SI-21

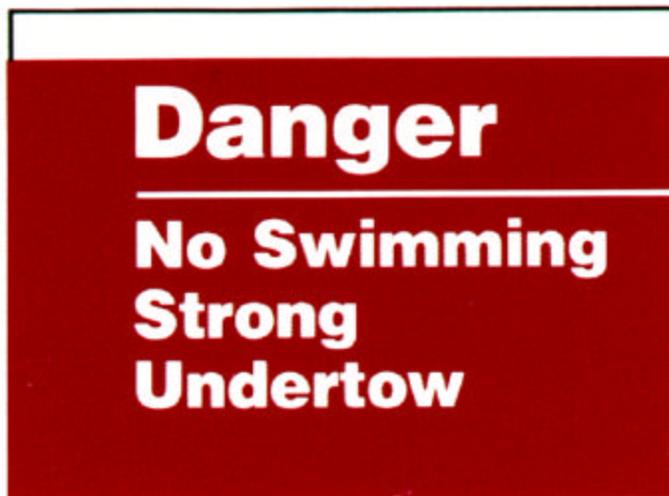
This sign was developed by the Minnesota Department of Natural Resources (MN DNR) for low head dams. It identifies non-obvious currents that may occur. The sign has been used commonly in Minnesota and other states, increasing public recognition through standardization of the warning. Well designed specialty graphic increases effectiveness. (Used with permission: Copyright, 2001 Minnesota Department of Natural Resources. Contact MN DNR Boating Safety Section (651) 296-3336 for permission to use.)

None.
